Tuck O'Brien
City Planning Director, Planning Division

Re: 48 Hancock Street – Project Number 2015-00033

The Hawk SOE

REVISED SITE PLAN
MAY 19, 2016

TITLE: Excavation Support
PROJECT: 48 Hancock St
LOCATION: Portland, ME
DATE: 3/16/2016
SCALE: AS NOTED REVISION:

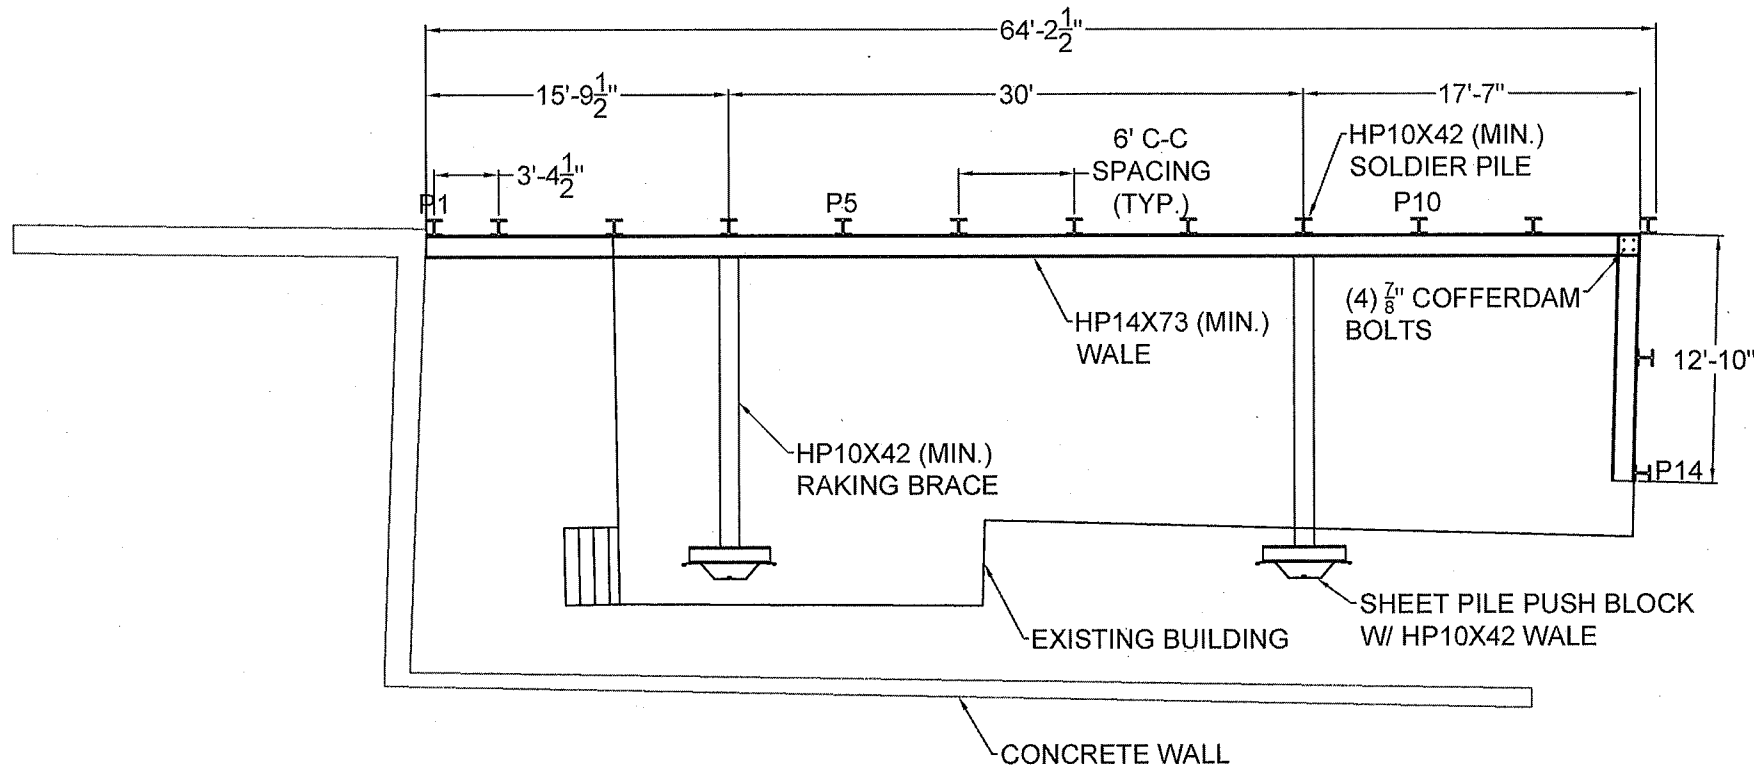
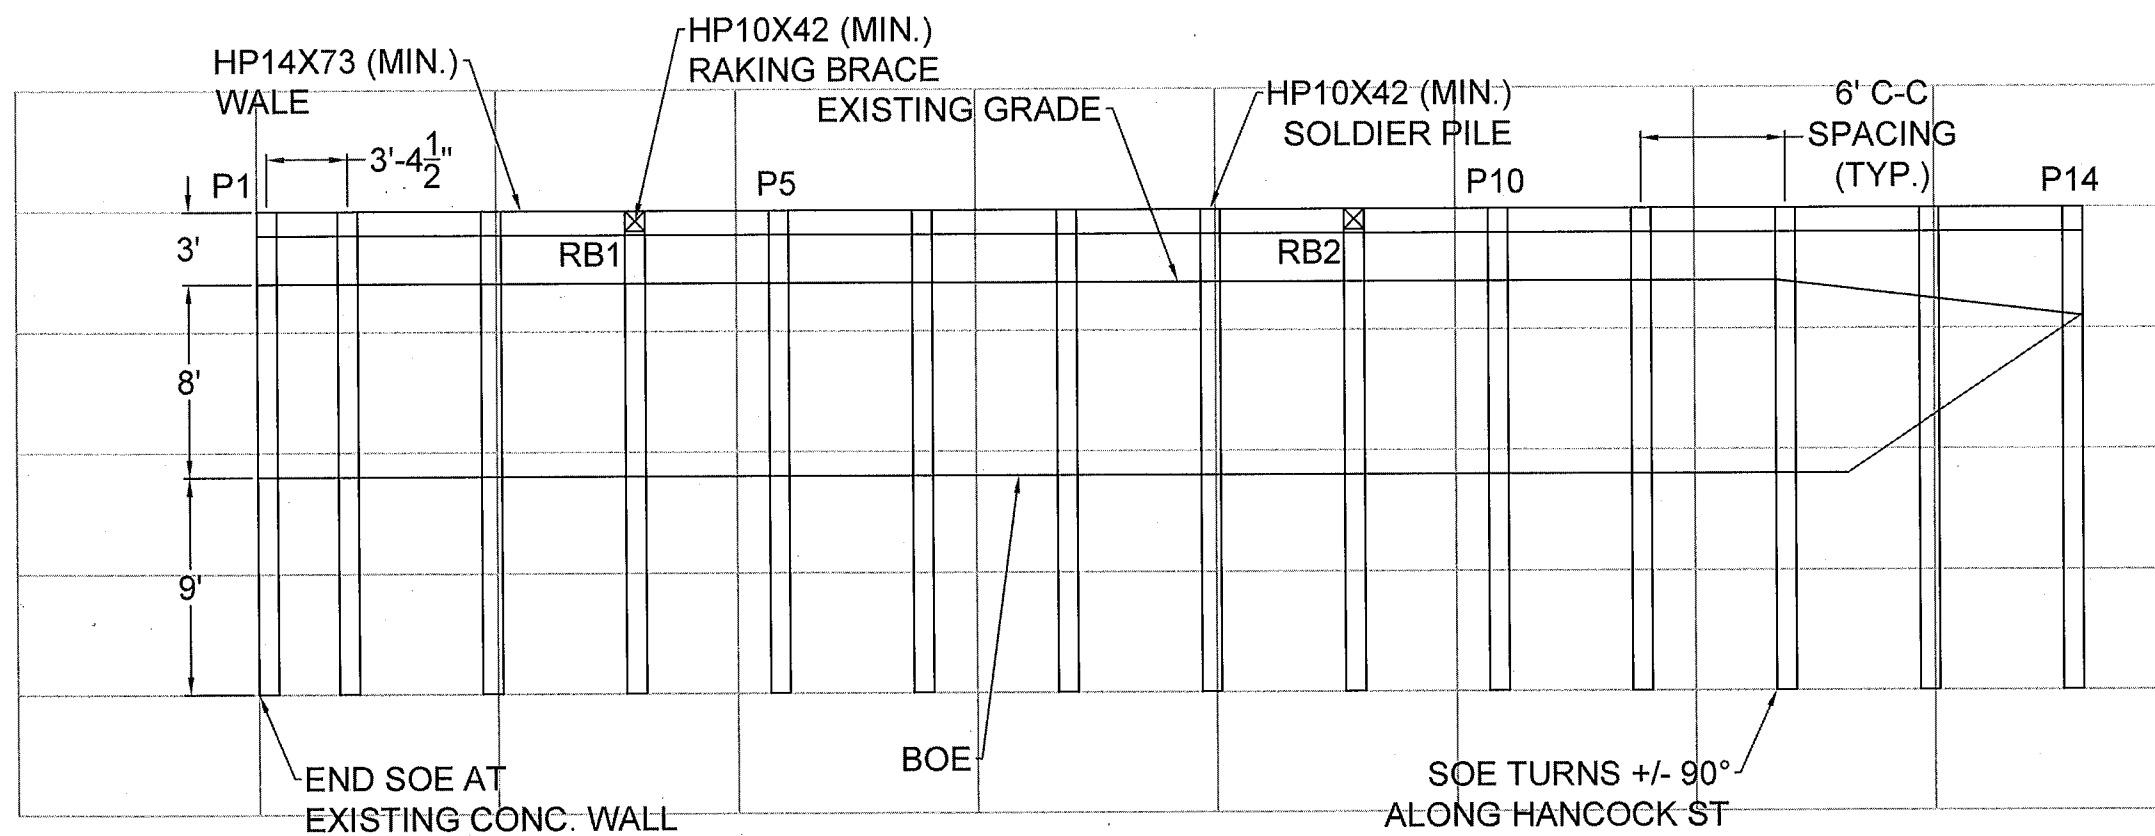
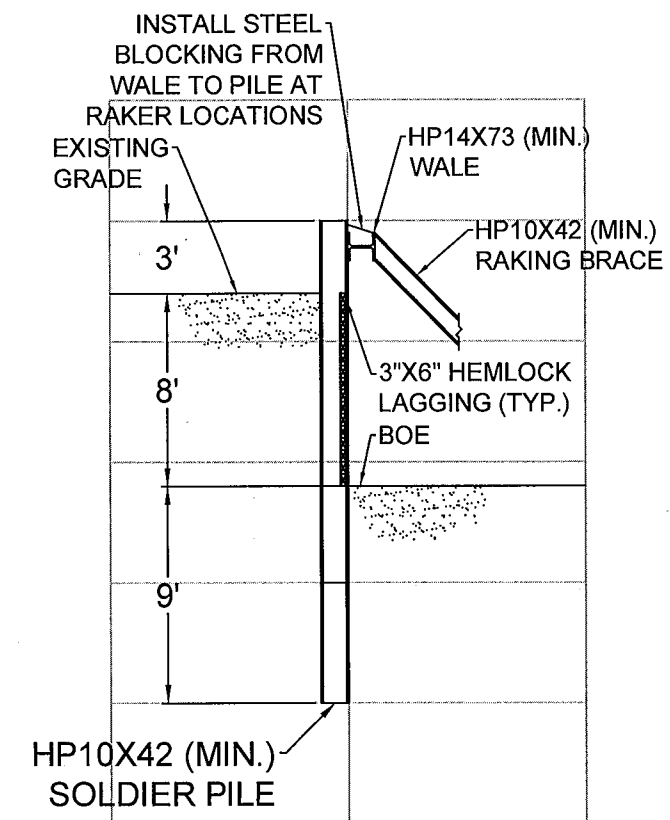
The plans by HB Fleming show an intersection of the SOE wall with an existing retaining wall at the rear of the property. This would require cutting

an old existing wall that continues to the south along the Filipos property line and then extends as an old "tabby" wall between the 113 Newbury and the Federal St. properties. (See circled area in accompanying photograph) This wall is in poor shape as pointed out in the letter submitted by Casco Bay Engineering and will likely suffer severe damage if cut to allow the SOE to intersect the rear property wall. Furthermore, once the SOE is removed, what will continue to support the property in this area?

As requested to me by the owners, we will be extending our pile system to address any safety concerns of the existing concrete wall. This wall will be below the 4' required height for permit review.

DATE: 5-3-2016

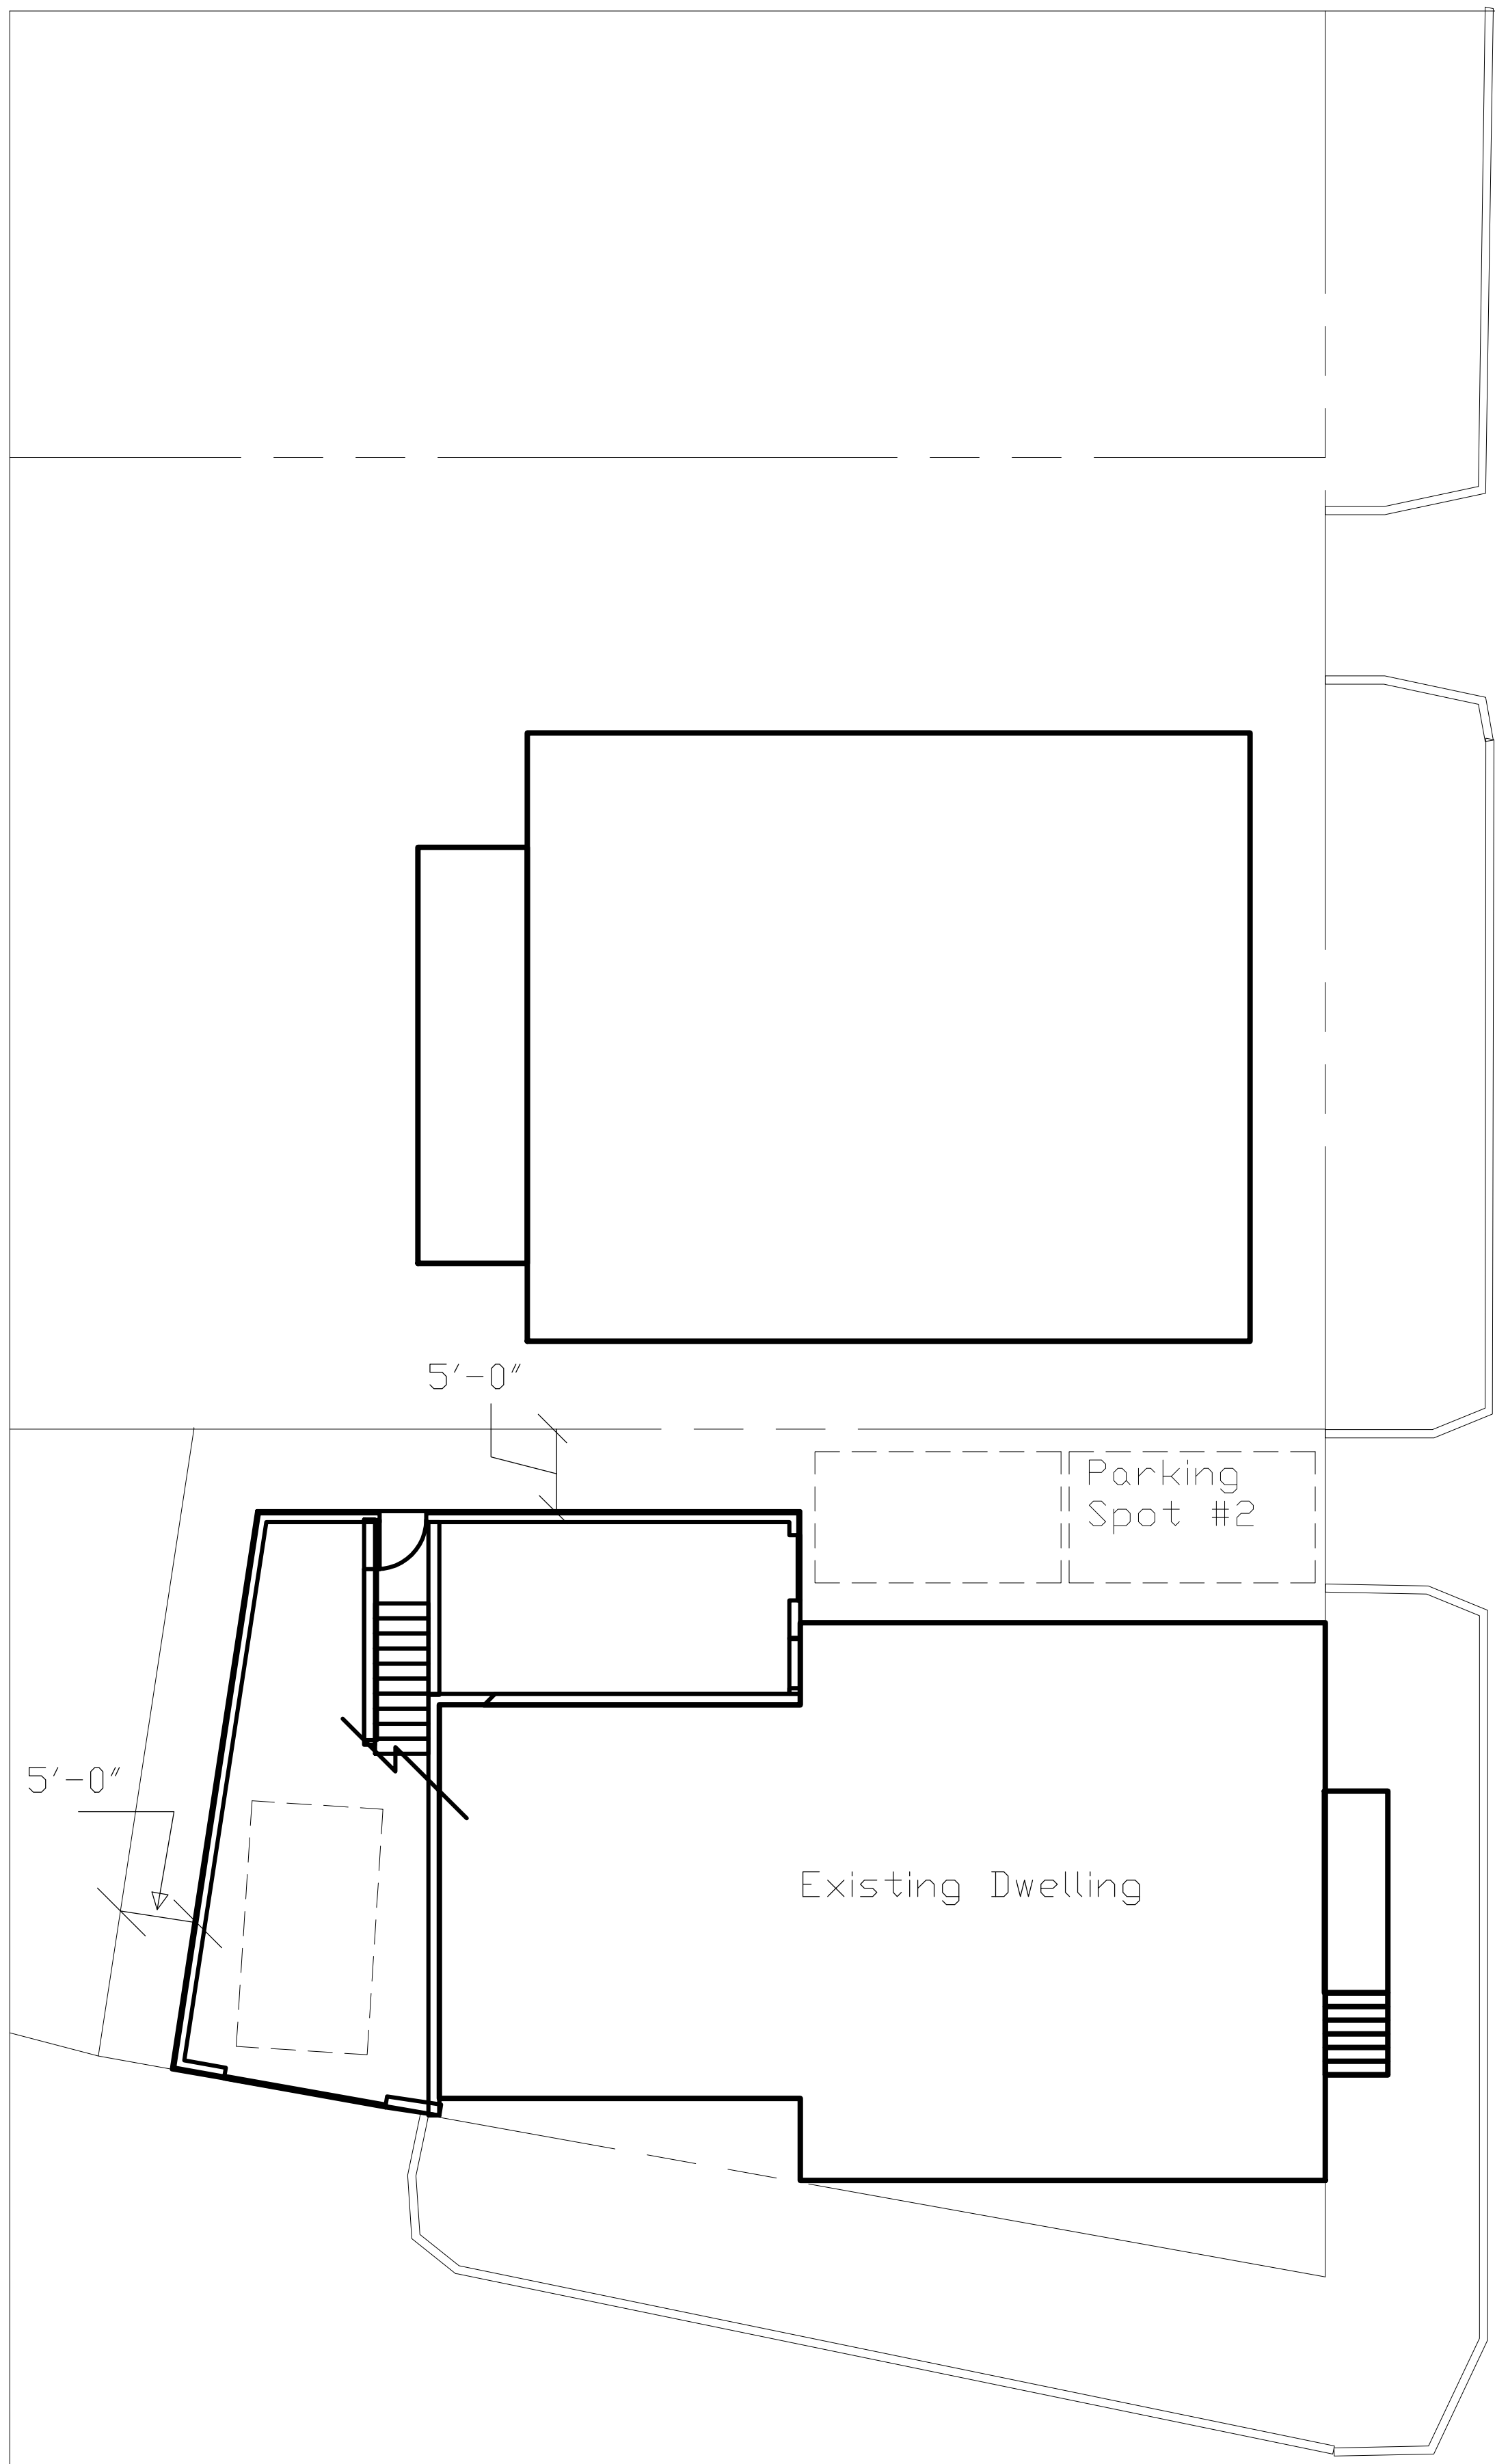
1. Mr. Linscott's e-mail states that they have performed a detailed soil pressure distribution and structural analysis in the design of the proposed excavation support system and that they have a third party analysis of the vibration data from a project in Kennebunk. Please include this analysis and vibration data or provide a detailed summary and a reference where it can be reviewed in the plan.

The vibration data is attached to this plan. Please note that all levels are well below the lowest published threshold criteria for construction vibrations of .5 in/sec.
